**LAND NORTHEAST OF
M1 JUNCTION 22,
MARKFIELD,
LEICESTERSHIRE**

**PROPOSED TOUCAN CROSSING
& SITE ACCESS ON A50**

**UPDATED STAGE 1
ROAD SAFETY AUDIT REPORT**

RKS Associates Ref: VRP2236-01- RSA 1

Appendix A

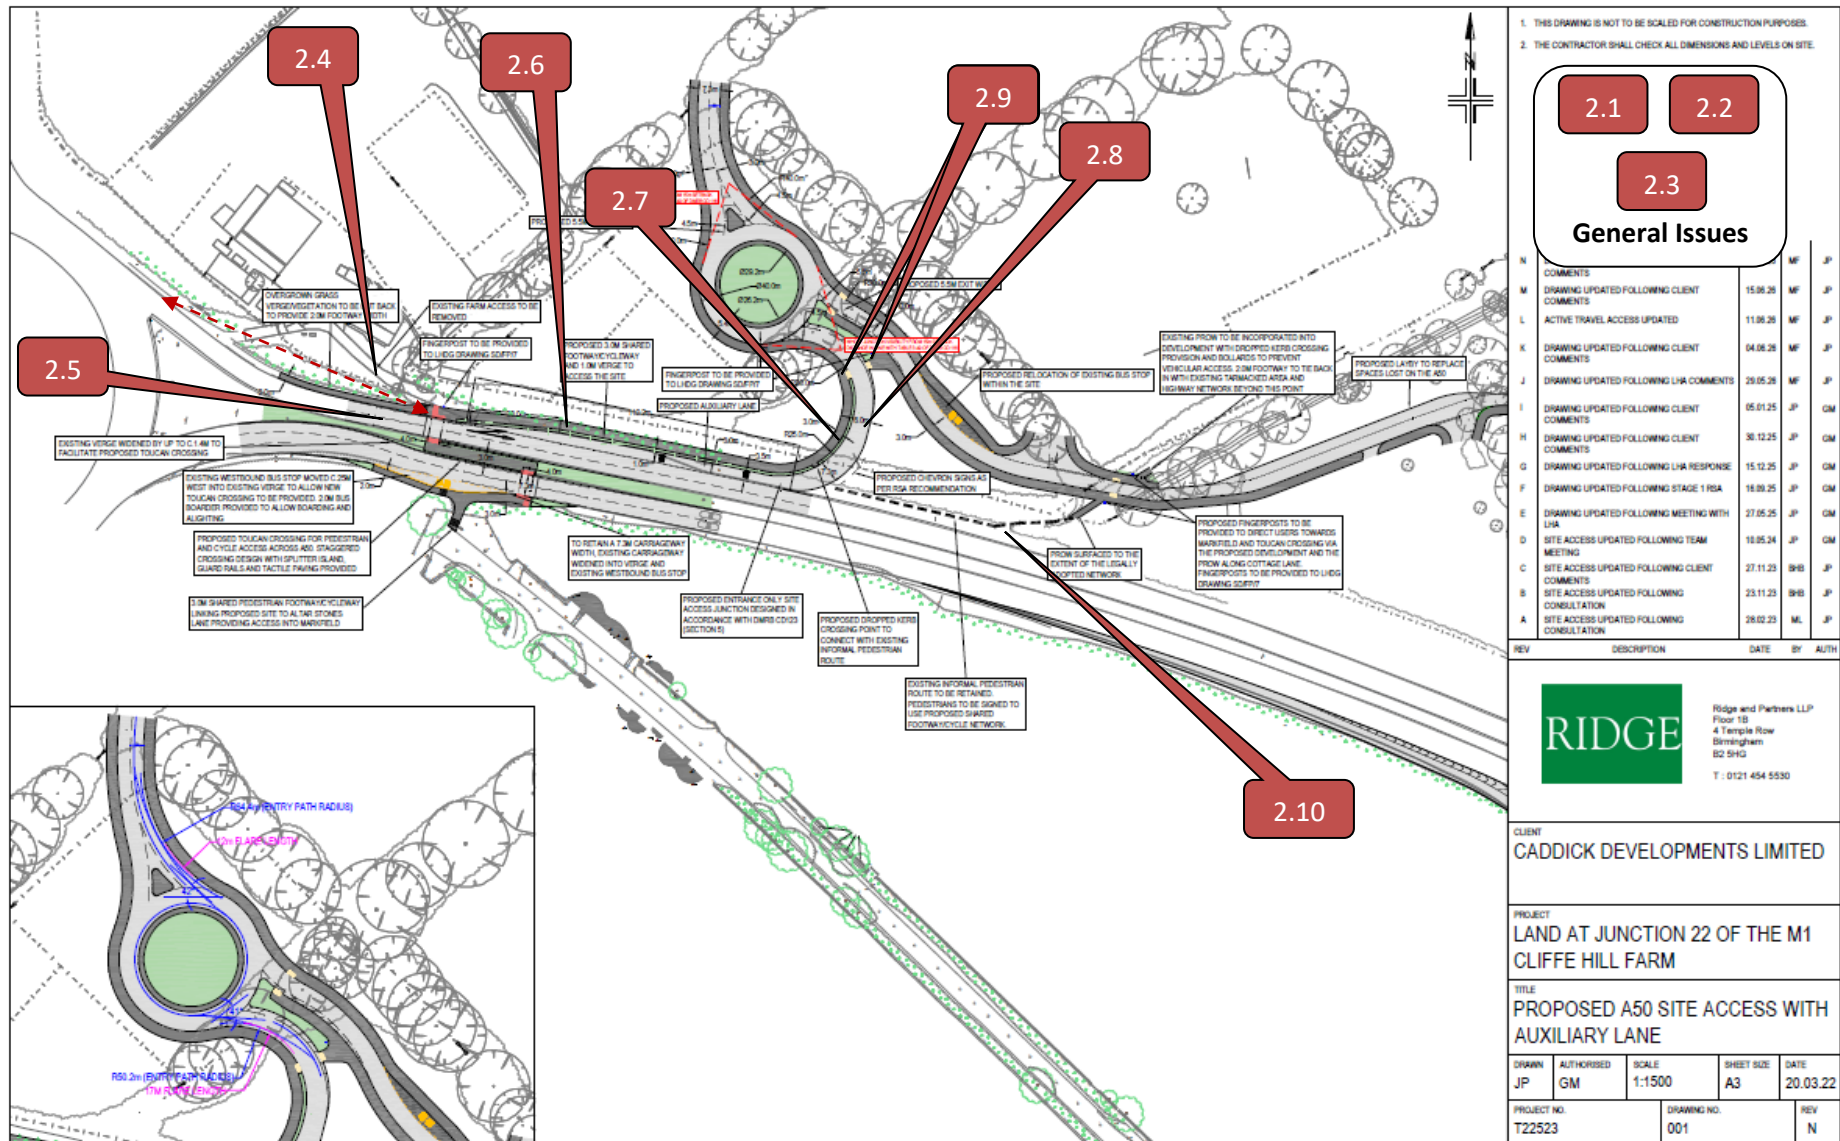
2.1 **Problem:**

Summary: Potential risk of collisions associated with poor drainage

2.2 **Problem:**

Summary: Potential risk of collisions associated with unclear layout

2.3 **Problem**

Summary: Potential risk of cycle collisions associated with poor facility

Problem:

Summary: Potential risk of collisions associated with poor visibility

Problem:

Summary: Potential risk of loss of control collisions associated poor carriageway surface

Problem:

Summary: Potential risk of speed related/loss of control collisions

Problem:

Summary: Potential risk of loss of control collisions associated with carriageway space
Location: *Proposed development access*

Problem:

Summary: Potential risk of collisions associated with vertical alignment
Location: *Proposed development access*

Problem:

Summary: Potential risk of non-motorised users struck by passing traffic
Location: *Proposed crossing facility across development access road*

Problem:

Summary: Potential risk of pedestrian collisions associated with poor provision

CLIENT CADDICK DEVELOPMENTS LIMITED				
PROJECT LAND AT JUNCTION 22 OF THE M1 CLIFFE HILL FARM				
TITLE PROPOSED CROSSING POINT VISIBILITY SPLAYS				
DRAWN	AUTHORISED	SCALE	SHEET SIZE	DATE
MF	JP	1:1500	A3	01.07.26
PROJECT NO.		DRAWING NO.		REV
T22523		010		A

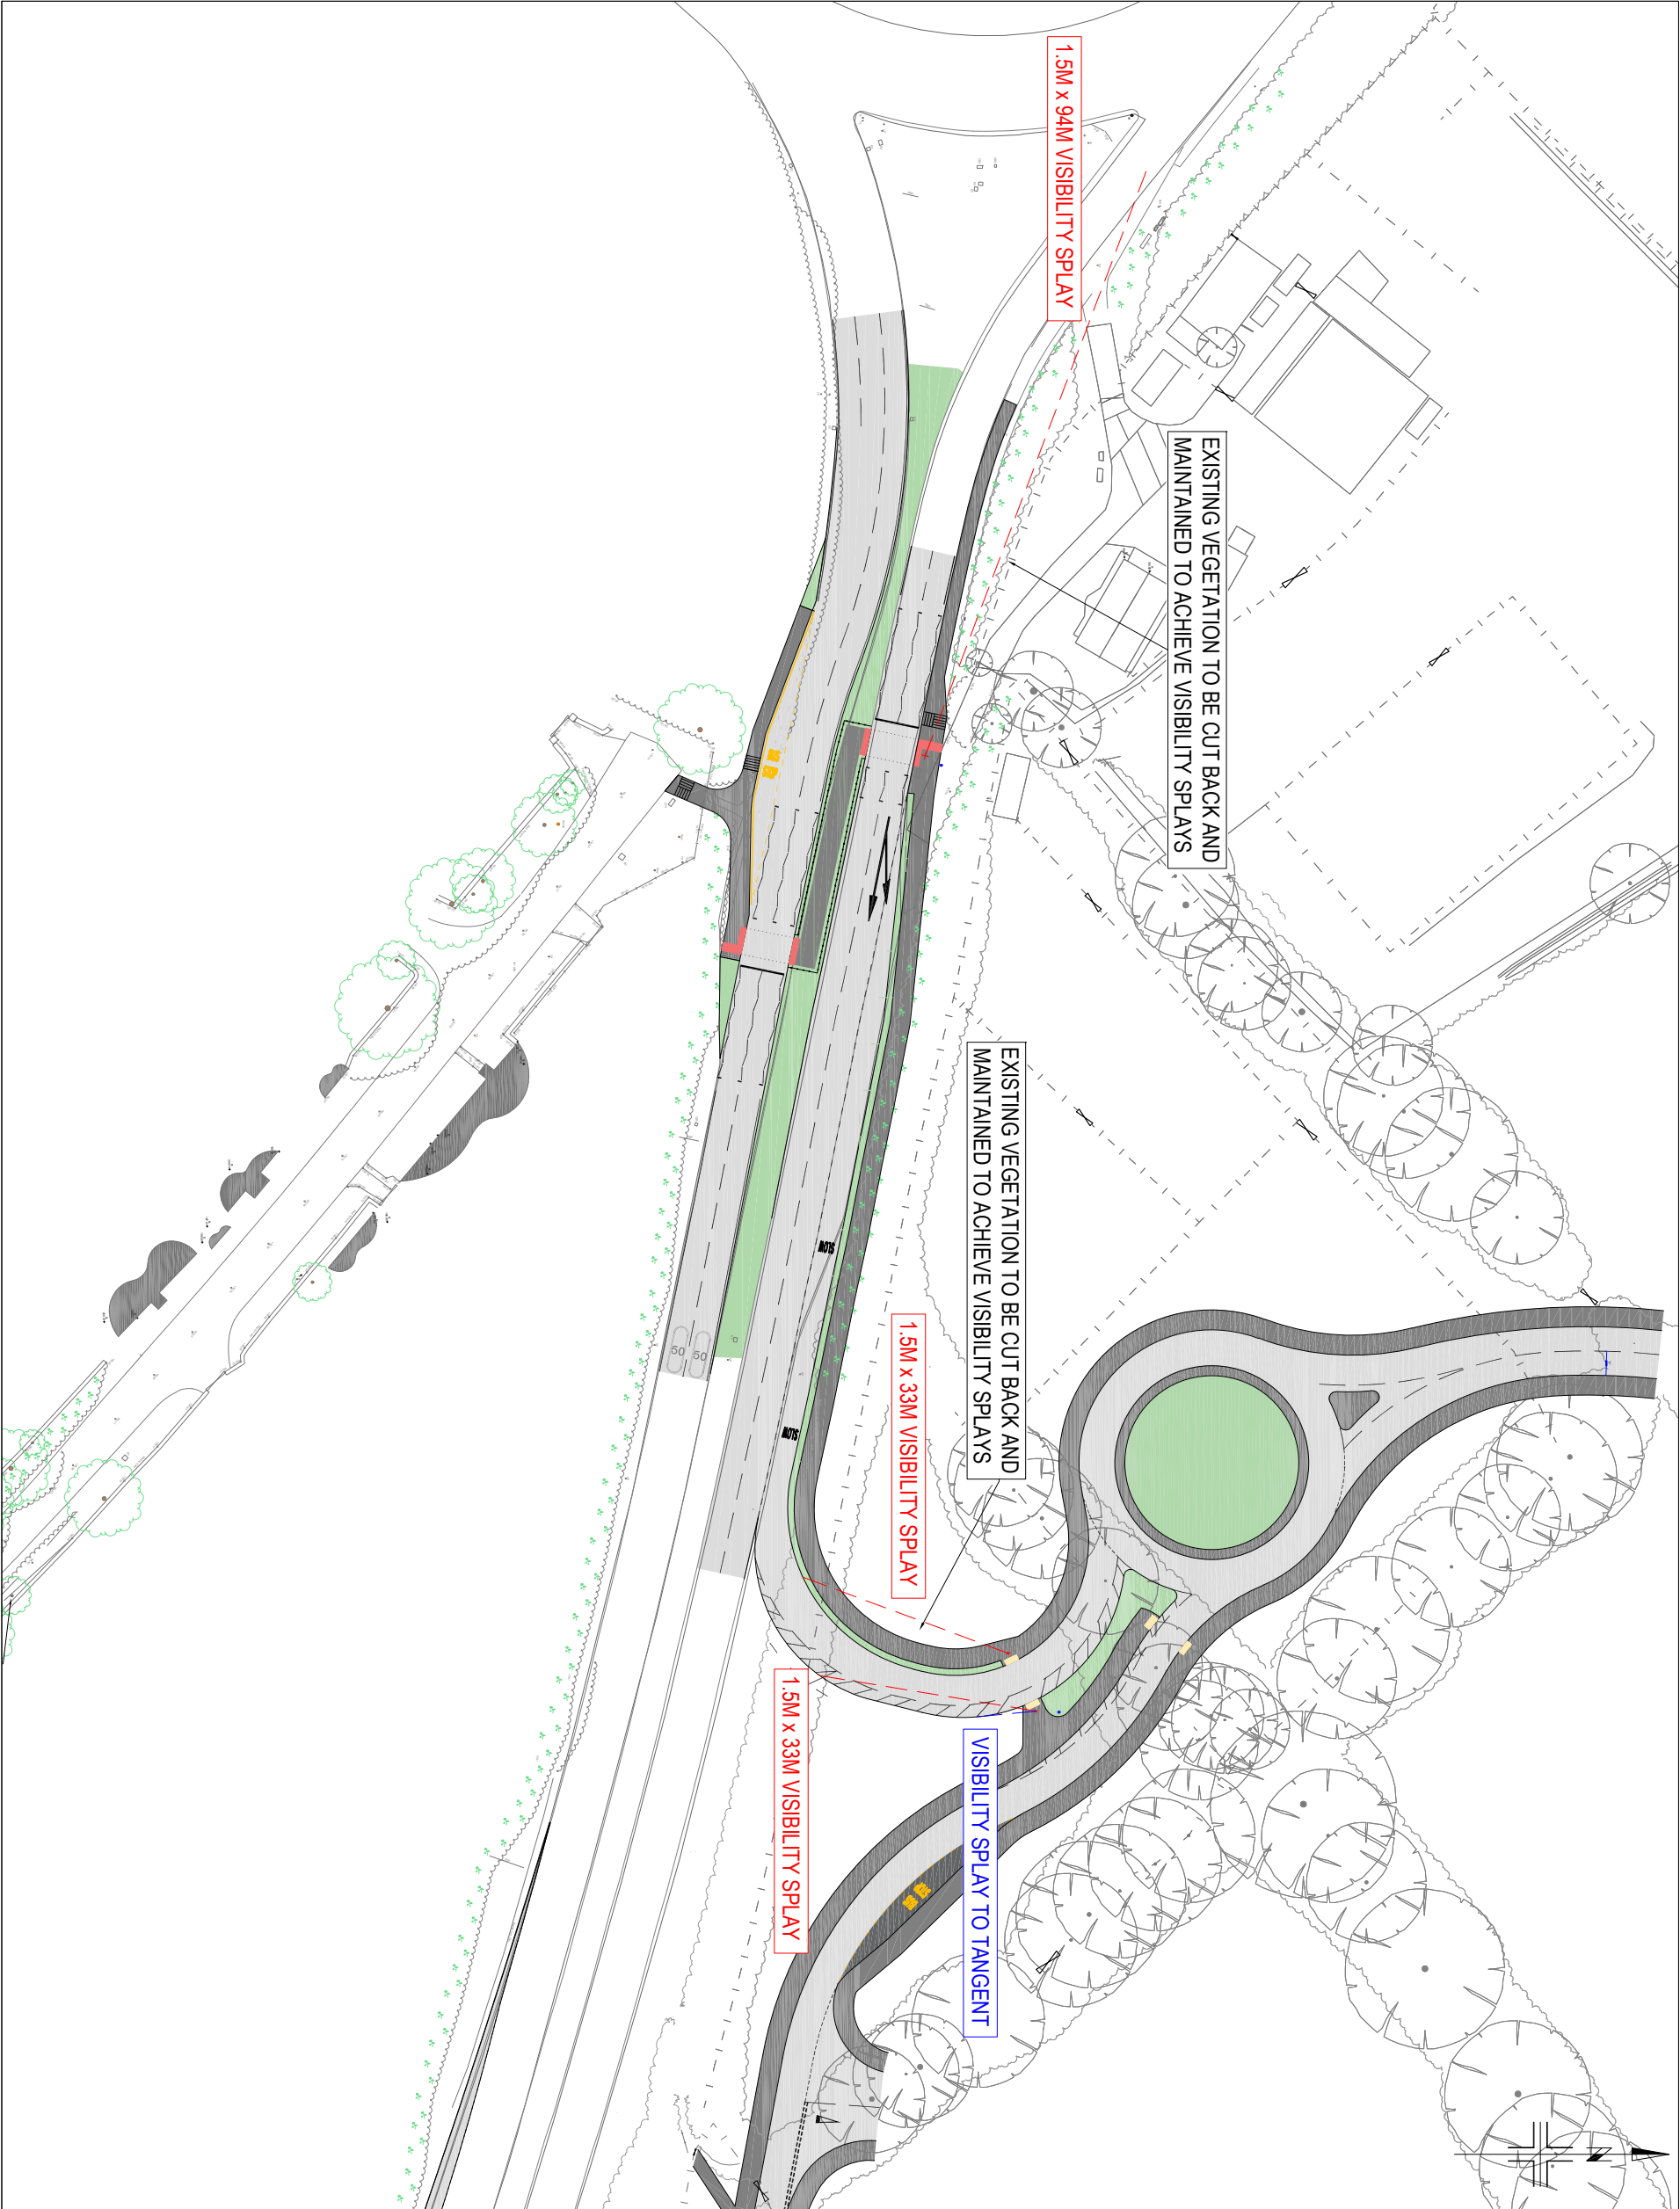
2.7	The proposed width of the access road serving the development varies in width from 7.3m on the entry to 6m on the approach to the internal site access roundabout. The vehicle swept path analysis provided indicate that large vehicles can negotiate the access road, however where the width narrows there is concern that larger vehicles may overrun the kerbs/verge. This may increase the risk of loss of control collisions which may be exuberated by vehicles travelling at inappropriate speed whilst traversing the bend in the road.	Review the layout, the access road should be of a consistent width with carriageway hatch markings used to direct vehicles safely around the bend.	Partly accepted. Vehicle swept paths for an 18.55m HGV have been provided and show that they can comfortably negotiate the bend without overrunning the kerb line as proposed. However, the design has been updated to provide hatching around the whole bend to guide drivers from the auxiliary lane to the roundabout approach. Please refer to Drawing T22523.010 rev A .

2.9	No details relating to the visibility splays to and from the tactile landings at the proposed uncontrolled crossing facility across the proposed development entry have been provided. There is concern that visibility to and from the proposed tactile landings may be compromised by vegetation which may lead to non-motorised users entering the carriageway to observe oncoming traffic leading to an increased risk of them being struck by vehicles.	Ensure visibility splays to and from the tactile landings at the proposed uncontrolled crossing facility across the development access road are provided. Vegetation within/behind the visibility splays should be cut back and regularly maintained, alternatively move the crossing facility closer towards development access roundabout.	Accepted. Please refer to Drawing T22523.010 rev A . The cutting back of vegetation will form part of the s278 works.
